Subject: AP1000 Response to Request for Additional Information (TR03)

Response to Request for Additional Information on Technical Report 03

RAI Response Number: RAI-TR03-010
Revision: 4

Figure RAI-TR03-15-1-Strain-iterated shear wave velocity profiles

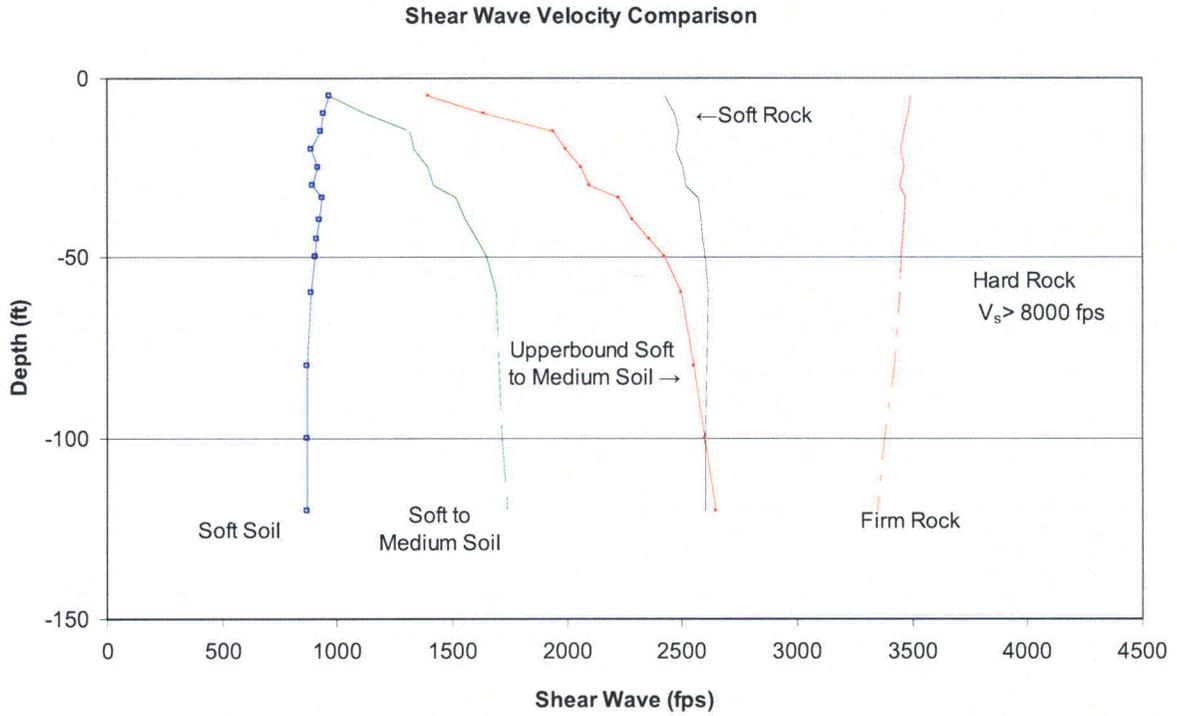
In Page 48 of 154, Westinghouse illustrated that some effects (water table, soil layering, soil degradation model, etc.) are not significant to the seismic response of the nuclear island (NI) structures. Because these results are applied for the AP1000 design, the staff requests Westinghouse provide technical basis for making these conclusions. In addition, Westinghouse needs to demonstrate the combination of these effects is also insignificant to the seismic response of the NI structures.

Westinghouse has addressed soil degradation in RAI-TR03-10. Tables of strain-iterated shear wave velocity used in the generic analyses are shown in Table 4.4.1-3 of Technical Report 03. Figure RAI-TR03-15-1 shows the bounds of these strain-iterated shear wave velocity profiles. The combination of effects of the different soil parameters is reflected in these bounds. Figure RAI-TR03-15-2 shows how a COL applicant could demonstrate that the site is enveloped by generic seismic design basis. The applicant would define its site geotechnical parameters as defined in DCD Section 2.5 and would justify why the site is within the bounds of the AP1000 generic analyses that have been considered in this technical report. These parameters would include the soil profiles used in the PSHA (probabilistic seismic hazard analysis) analyses,

which could then be compared to Figure RAI-TR03-15-1. Subsequent discussions between the COL applicant and the NRC may uncover a parameter for which more justification is required to show that the impact of this parameter on the response is small. This justification could be done with the AP1000 2D model (See RAI-TR03-010, Rev. 4 for clarification of the use of 2D analyses). An example of how a 2D parametric study would be used is shown in Figure RAI-TR03-15-3 and RAI-TR03-15-4. If the parametric 2D SASSI studies show that the effect could be significant (e.g., 90% of the design spectrum, see Figure RAI-TR03-15-4) when compared to the 2D design spectra, a 3D SASSI study would then be performed. If the 3D SASSI analyses show some exceedances at the critical locations, the applicant would then proceed to show that sufficient margin exists in the design to accommodate these exceedances.

Figure RAI-TR03-016-001: Regions Surrounding Major Penetrations

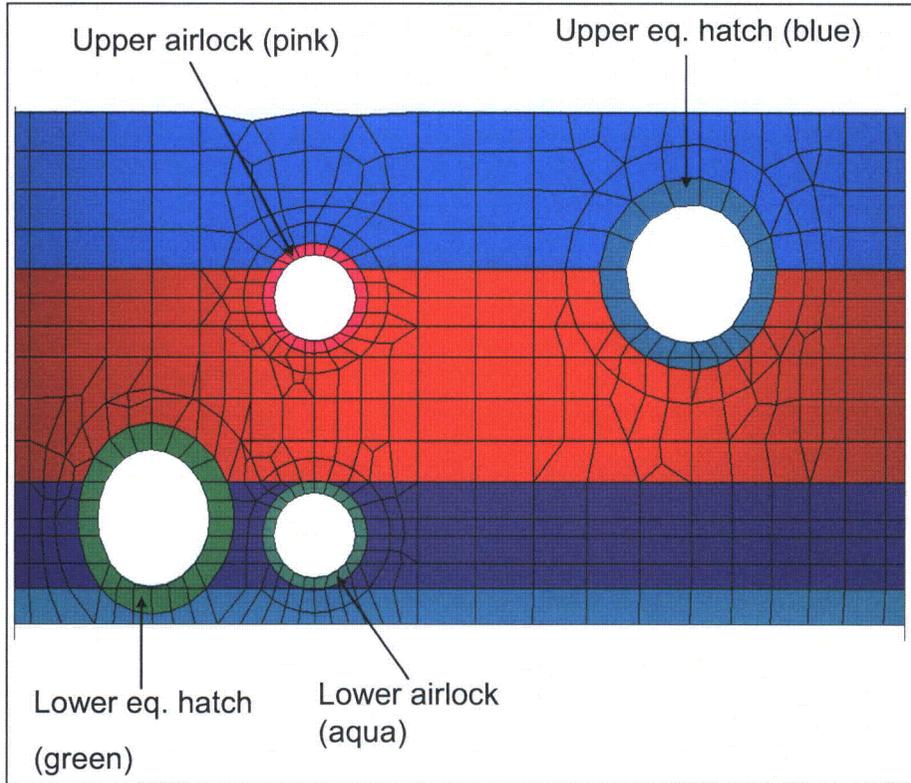
Westinghouse should demonstrate that the adequacy of using results from equivalent static acceleration analyses for the SSE response in the evaluation of the large penetrations.

Additionally, a time history analysis has been performed selecting information for the regions immediately surrounding the large penetrations as shown in Figure RAI-TR03-016-001. The purpose of this analysis is to verify that the loads from equivalent static analysis are conservative to time history using a representative study. The effects of the missing mass in the time history analysis have been incorporated by an algebraic sum of the stress intensities from a run with the left out mass accelerated at ZPA and the modal superposition time history analysis.

Figure RAI-TR03-024-1 - ASB Stick Portion of NI Combined Model

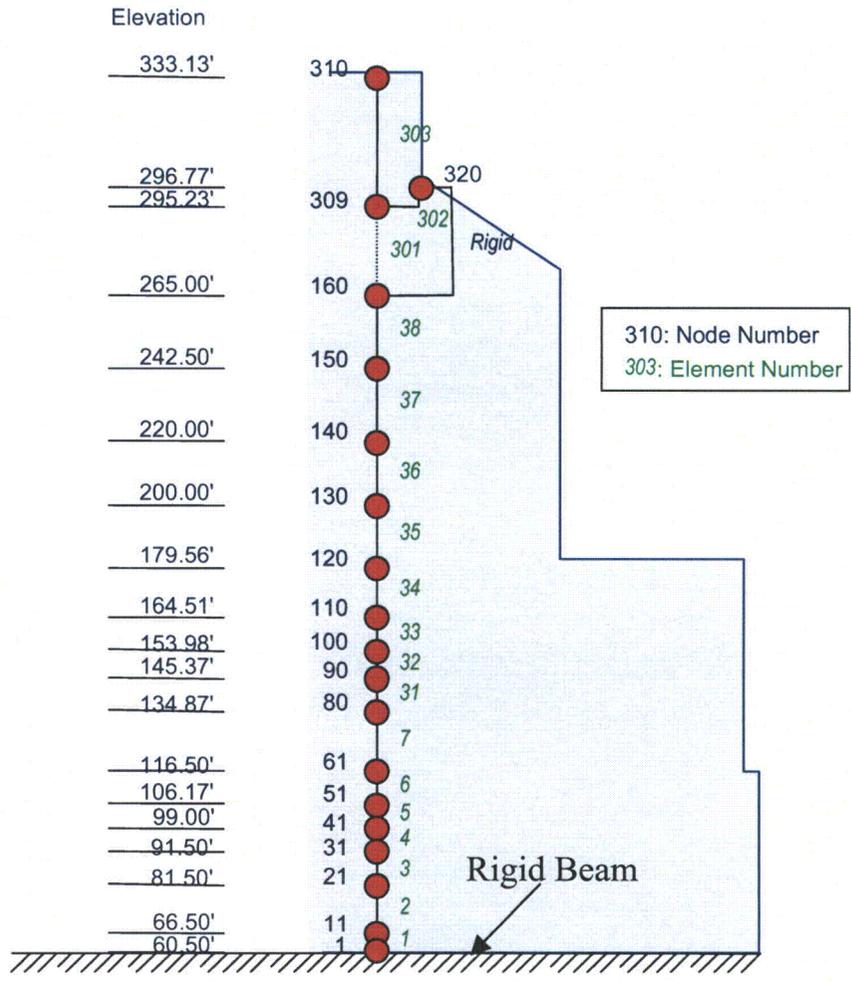
The description of Section 7.1 does not indicate whether the vertical spring/damper values were based on the rocking site stiffness value or the vertical site stiffness value and whether the horizontal/vertical parameters were determined from an assumed uniform half-space. Westinghouse should explain what are the differences in these parameters and how significant are these parameters on the computed results.

Lift off was evaluated using an East-West lumped-mass stick model of the nuclear island structures supported on a rigid basemat with nonlinear springs. This model is shown in Figure RAI-TR03-024-1. The liftoff analysis model consists of the following two elements:

Figure 7.2-3 Modeling of Actual Footprint in East-West Model

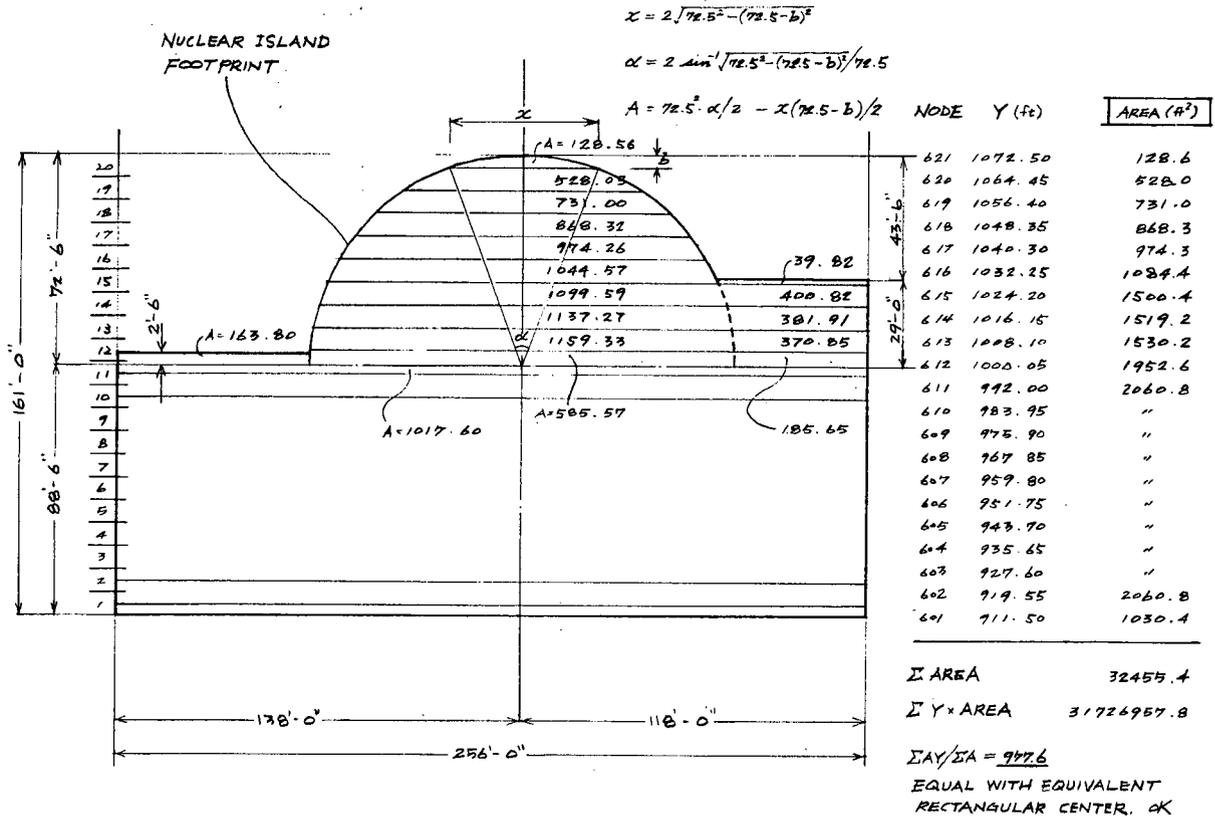
The description provided in Section 7.2 indicates that spring/dashpot values were selected based on parameters for a uniform half-space. However, for a soil site with hard rock located at a depth of 120 ft below the basemat, the resulting SSI radiation damping value would be expected to be significantly lower than that for a uniform half-space solution. Westinghouse should evaluate what is the impact of this difference on the computed seismic response?

The effect of liftoff during the safe shutdown earthquake of 0.3g and the review level earthquake of 0.5g was evaluated using the same approach described in section 7.1 for the hard rock site. The analyses used the East-West lumped-mass stick model of the nuclear island structures supported on a rigid basemat with nonlinear springs. The actual footprint of the basemat was used in the analyses of the East-West model (see Figure 7.2-3).
